TRUCK, ELECTRONIC, LIGHT, MC2, - LAND ROVER 110 6X6
ELECTRONIC REPAIR VEHICLE (ERV)

MODIFICATIONS TO THE MODULE AIR-CONDITIONING SYSTEM

MODIFICATION INSTRUCTION

Figure 1 - Fan Blade Location

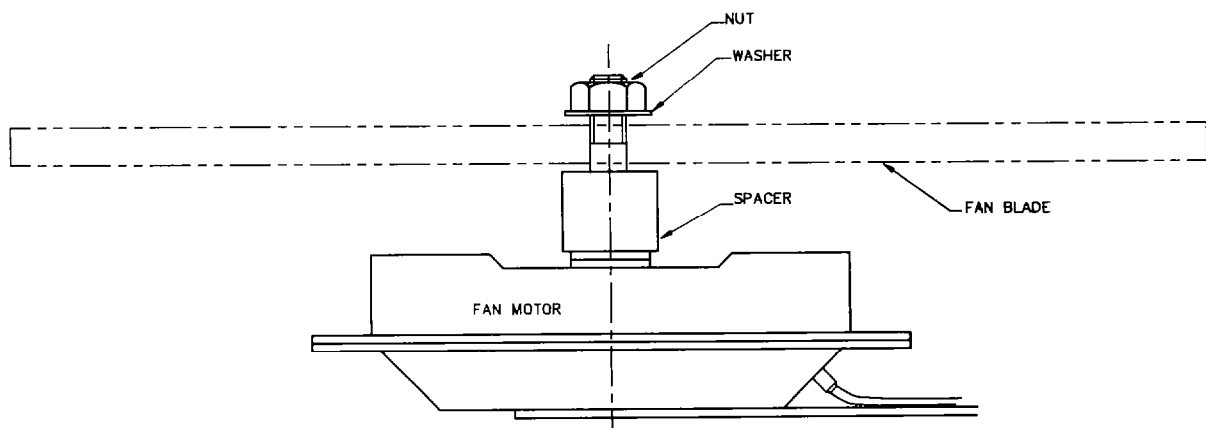
- f. Locate the new motor in the fan shroud and secure with two self tapping screws.
- g. Locate the fan blade on to the motor shaft (making sure the shaft spacer is located before the fan blade) see Figure 1. Fit the flat washer and nut and tighten to 9 N.m.

Figure 2 - Direction of Air Flow for Condenser Fan

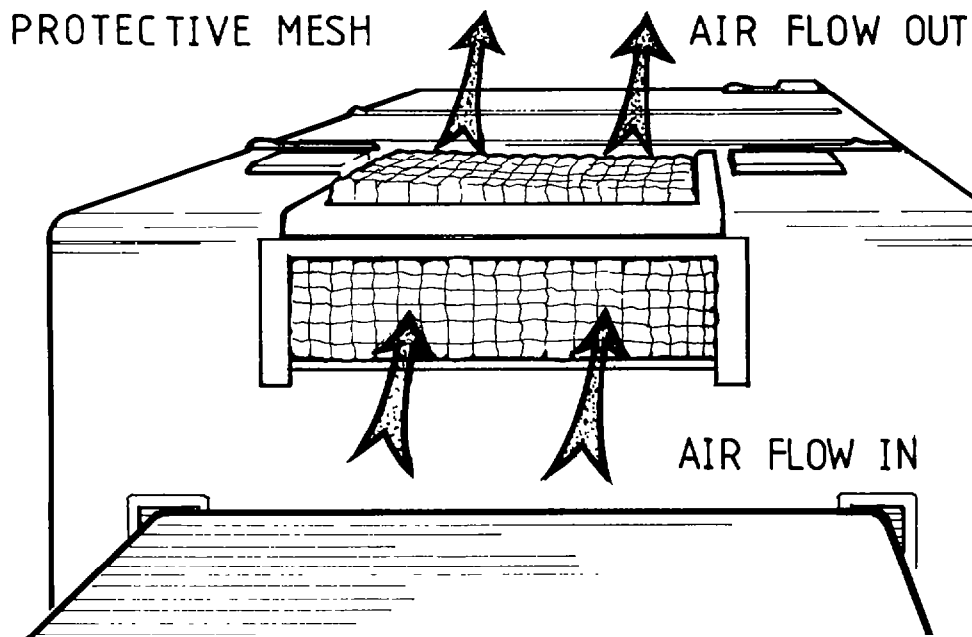
- h. Reassemble the fans into the condenser cover and reconnect wiring.
- i. Check the direction of air flow with the fans switched ON (air should be sucked through the condenser and blowing out through the fans and over the roof). See Figure 2.

Figure 3 - Fitting of Instruction and Warning Plates

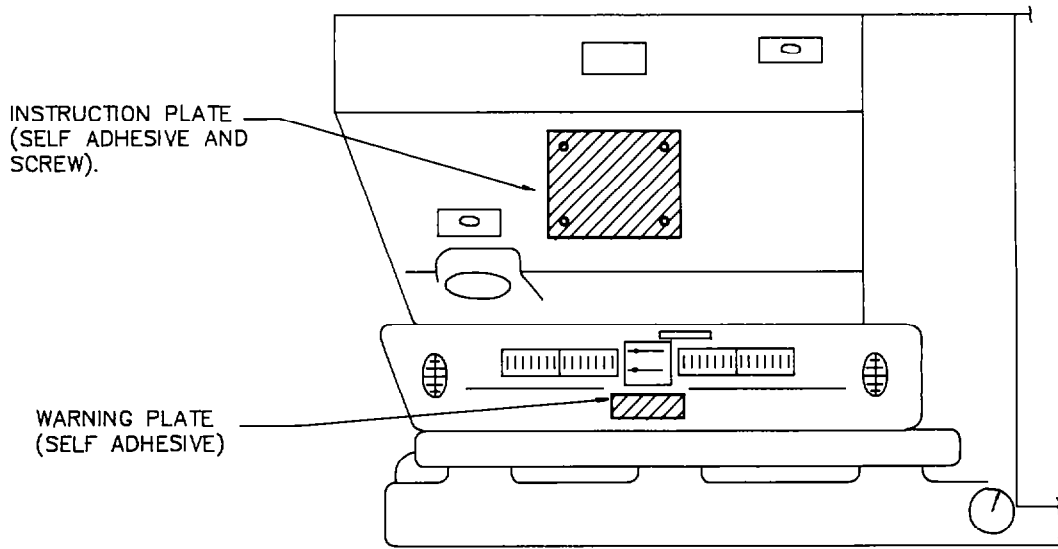
19. All applicable vehicles shown in Table 1 are to have the instruction and warning plates replaced by a Rover Australia dealer. Figure 3 shows the location of the plates. Both plates have a self adhesive backing, with the instruction plate being secured with an additional four self tapping screws.

Figure 4 - Correct Fitting of Receiver/Drier

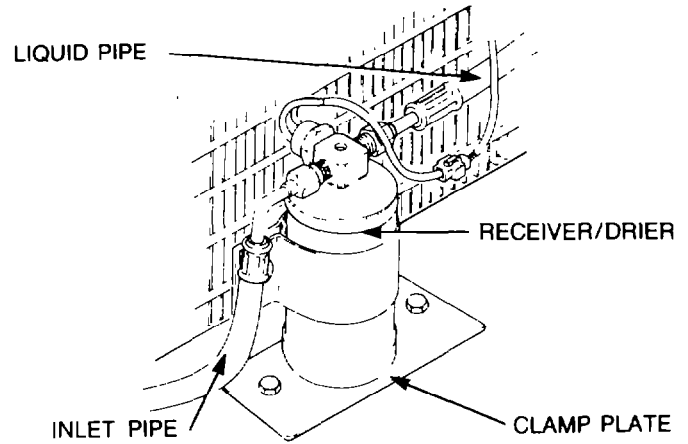
20. All applicable vehicles shown in Table 1 are to have the receiver/drier checked for correct fitting by a Rover Australia dealer. The receiver/drier is correctly fitted when the pressure switch faces the condenser when viewed through the mesh screen as shown in Figure 4. If the receiver/drier is incorrectly fitted then a new item is to be correctly fitted, under warranty, by the Rover Dealer.

Figure 5 - Position of Condenser Fan Mesh Screens

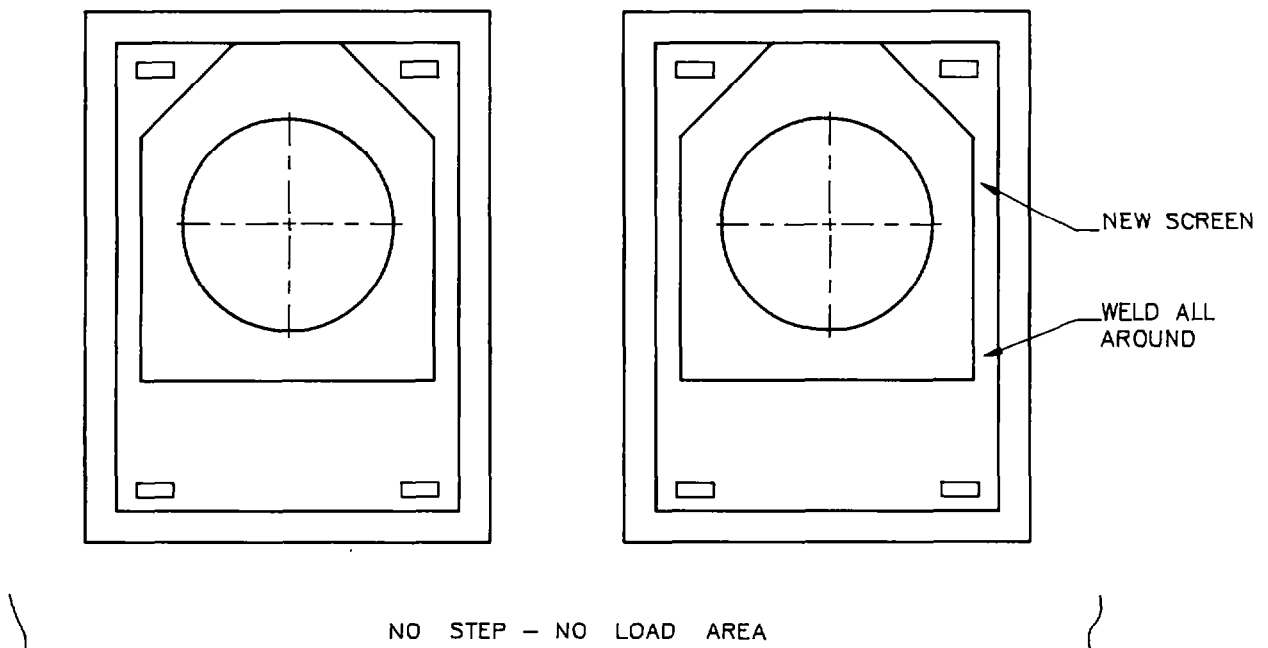
- a. Remove the existing condenser screens from the vehicle.
- b. Position the new mesh screen (Item 1, Table 3) directly above the fan area so that the chamfered corners face rearwards, as shown in Figure 5.

- c. Weld the new screen to the existing screen and paint damaged areas with cold gal paint and black paint.
- d. Refit the screens to the vehicle.

Figure 6 - Location of Travel Locking Bolt and Storage Hole

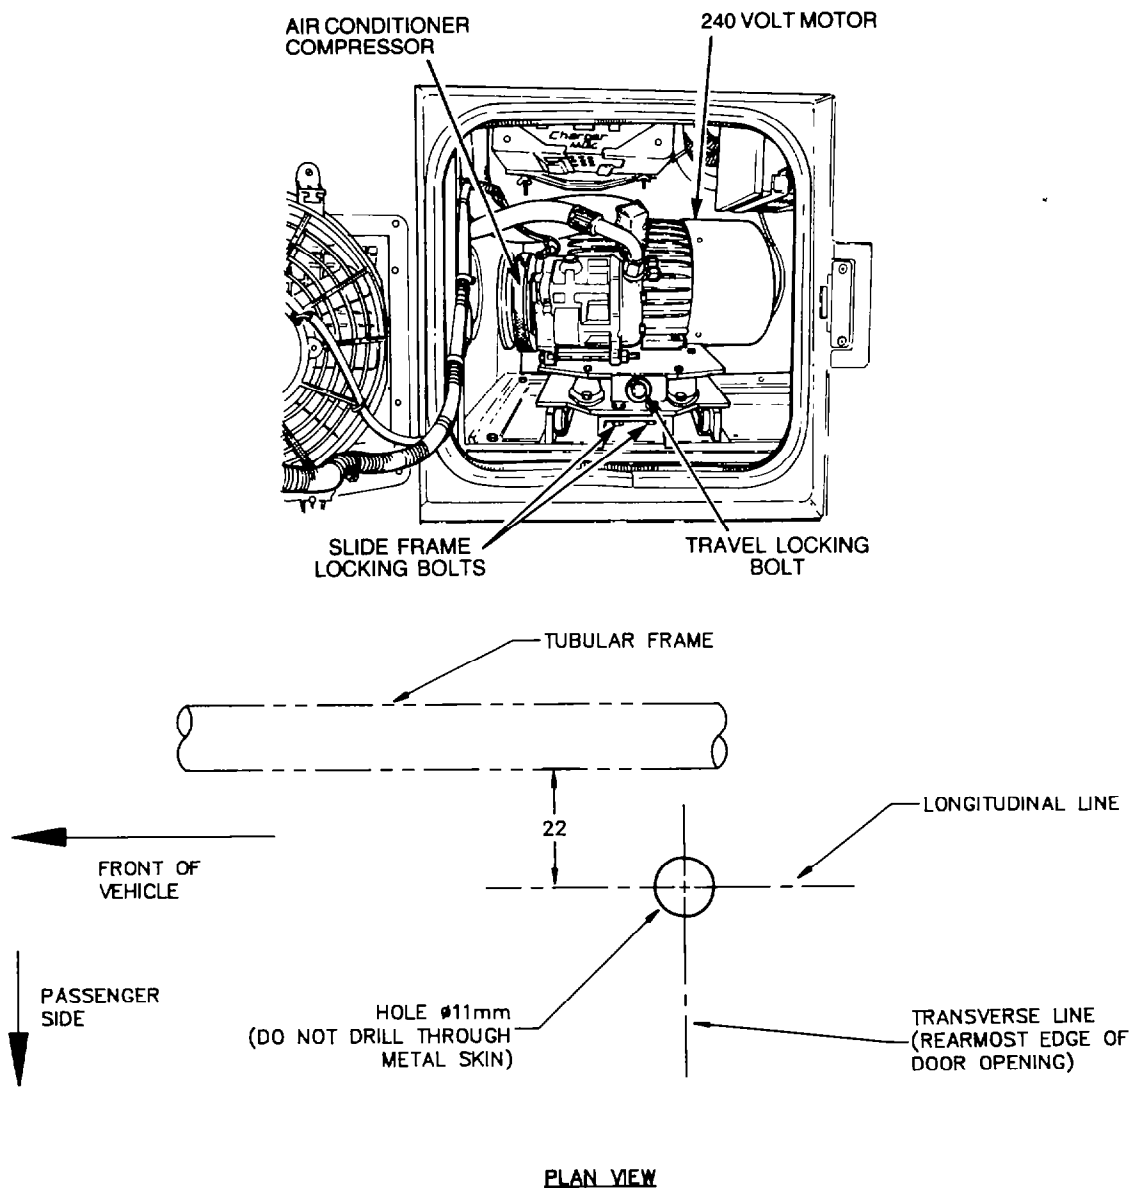
- a. Open the air-conditioner locker door and remove the existing travel locking bolt (see Figure 6).
- b. Fit the new 'T' bolt (Item 2, Table 3) in its place and secure the 'T' bolt chain washer under the head of the screw used to locate the rubber mount on the right side of the compressor mount plate.

c. Locate the position of the bolt storage hole (see Figure 6) as follows:

- (1) draw a transverse line from the rearmost edge of the door opening;
- (2) draw a longitudinal line parallel to, and 22 mm outboard from, the floor mounted tubular frame; and
- (3) drill an 11.0 mm diameter hole down through the plywood floor but not through the lower metal skin.

Figure 7 - Air-Conditioner and Thermostat Switch Relay Box

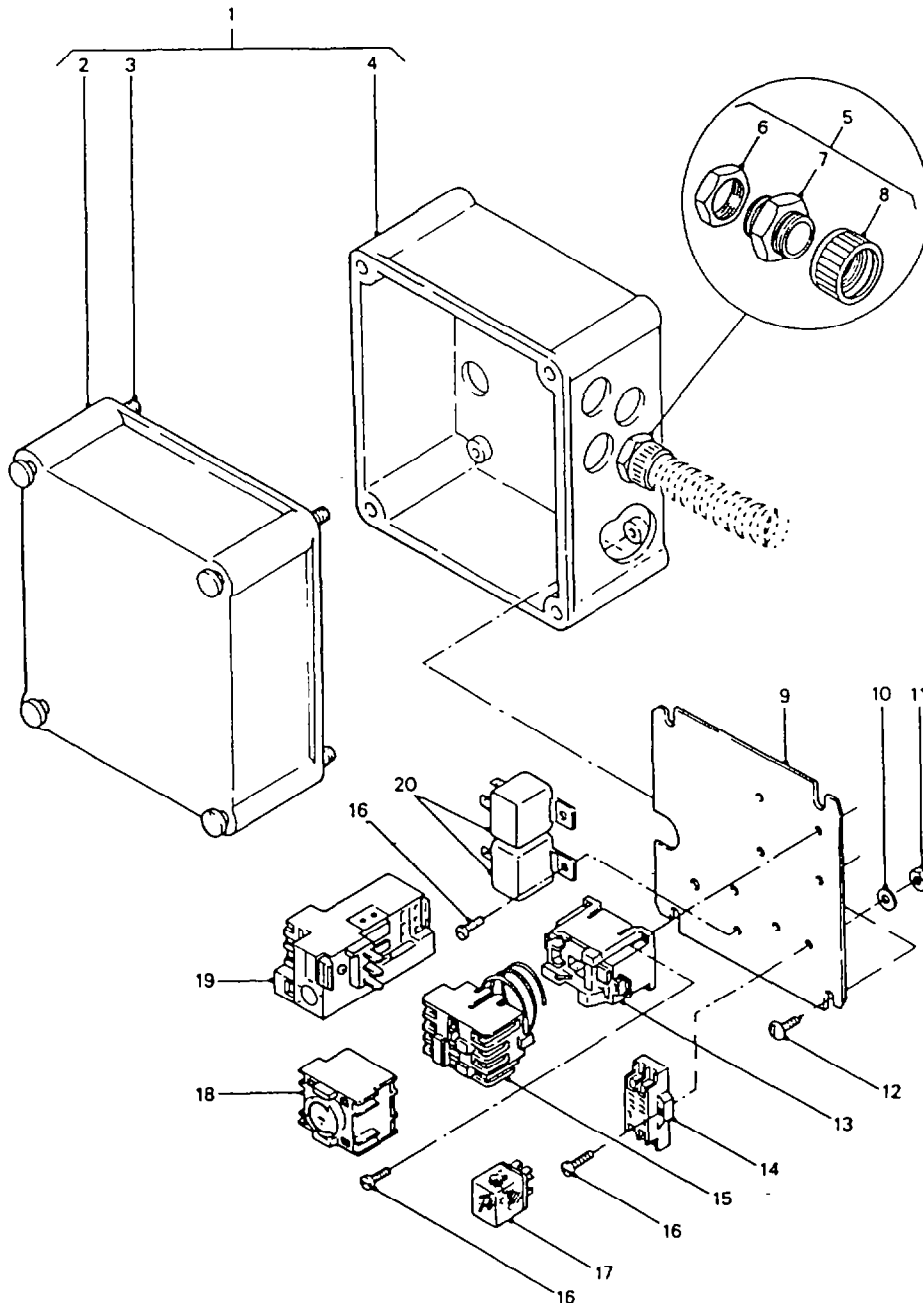
23. All applicable vehicles shown in Table 1 are to have the contactor (Item 3, Table 3) replaced by Army tradesmen. The contactor is being replaced due to constant problems with burnout. The failures are associated with the output limit of the 15 KVA generator when it is subjected to an instantaneous 240 volt motor start up load and corresponding voltage drop at the contactor coil. Proceed as follows:

- d. Identify the power box (Figure 7, Item 1) and remove the cover, then slide out the power divider plate.
- e. Slide the timer (Figure 7, Item 18) off the contactor by depressing the locking tongue at the front face.

- f. Unscrew overload mechanism from C1 contacts and retain (Figure 7, Item 19).
- g. Remove the four big headed screws holding the relay mounting plate in the back of the power box and slide out to provide access to the contactor base retaining screws nuts.

- h. Disconnect all wires and fixing screws from 'C1' contactor and remove from the control box (Figure 7, Item 15, 13).
- i. Install new contactor 'C1' with 24 volt DC coil.

Figure 8 - Connection of C1 Contactor Wiring

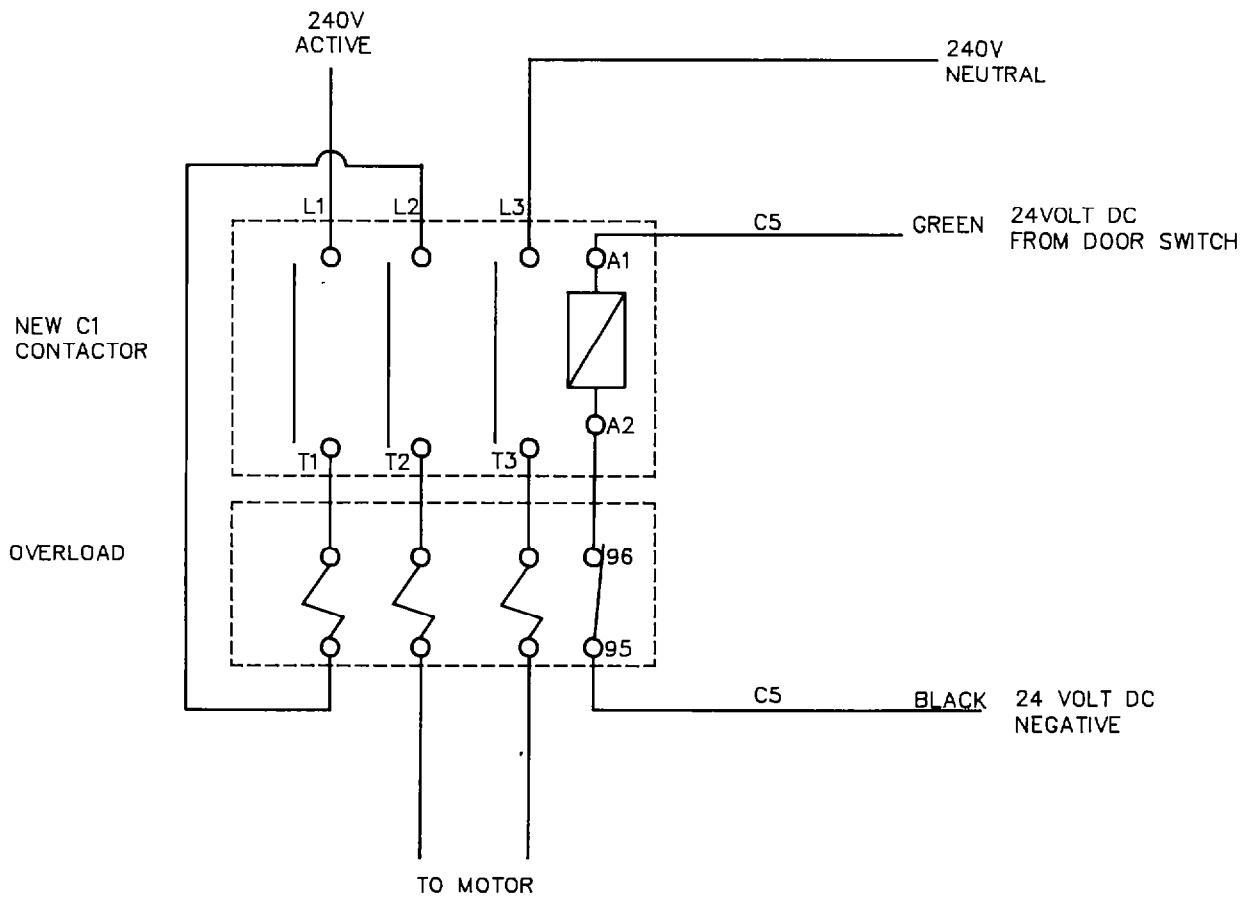
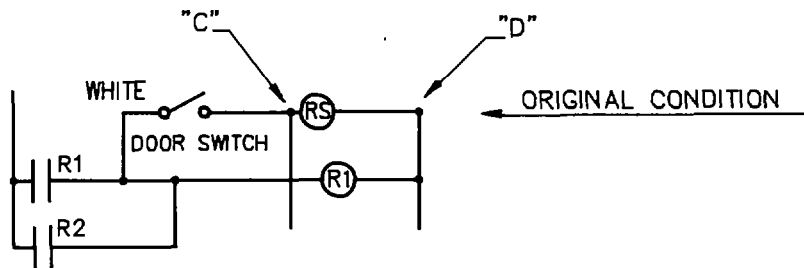
- j. Connect the new contactor 'C1' as shown in circuit diagram Figure 8.

The 24 volt connections can be made at the transparent relay base, right hand side top deck.

The relay is redundant and should be discarded.

Figure 9 - Revised Wiring (Door Switch)

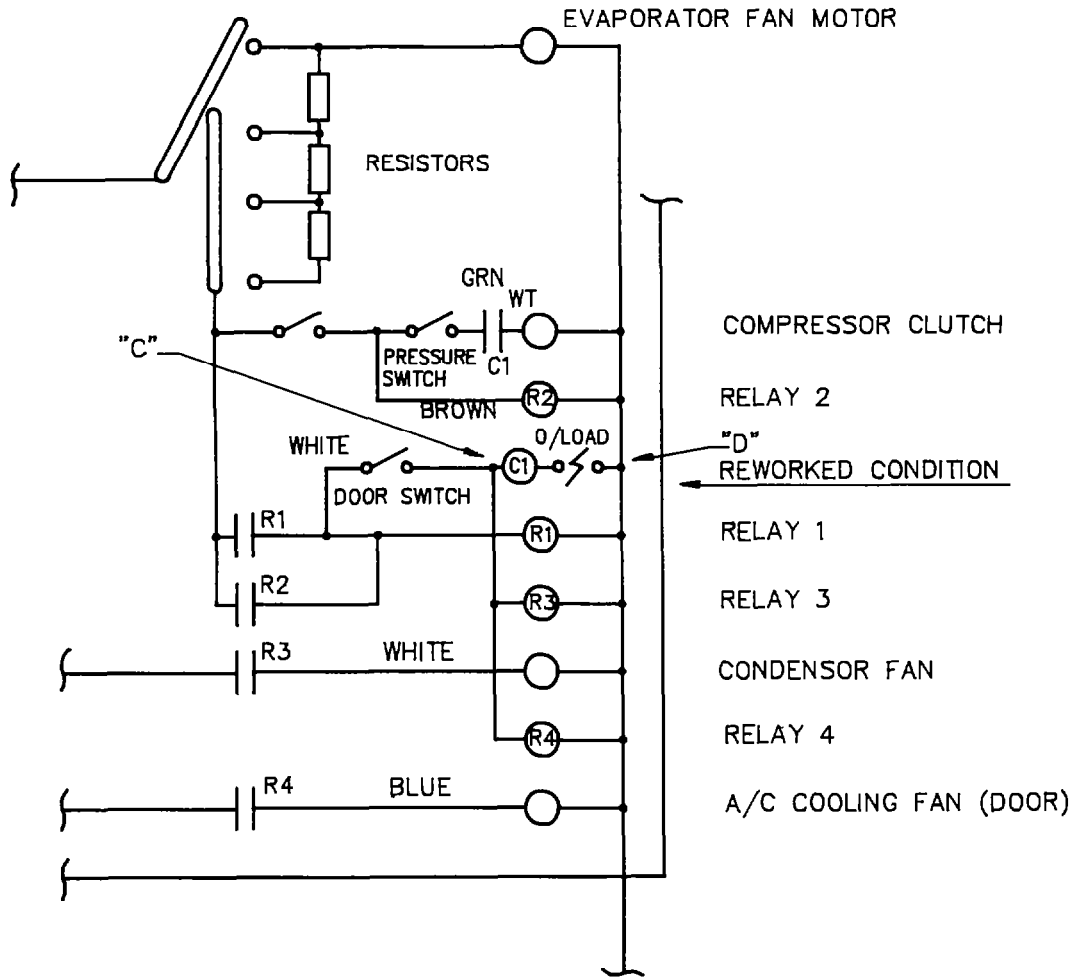
Revisions to the circuits are shown in Figures 9 and 10. A revised circuit diagram for EMEI Vehicle G 253 will be issued separately.

NOTE: CIRCUIT "C" AND "D" REVISED FROM 'ORIGINAL' CONDITION TO 'REWORKED' CONDITION.
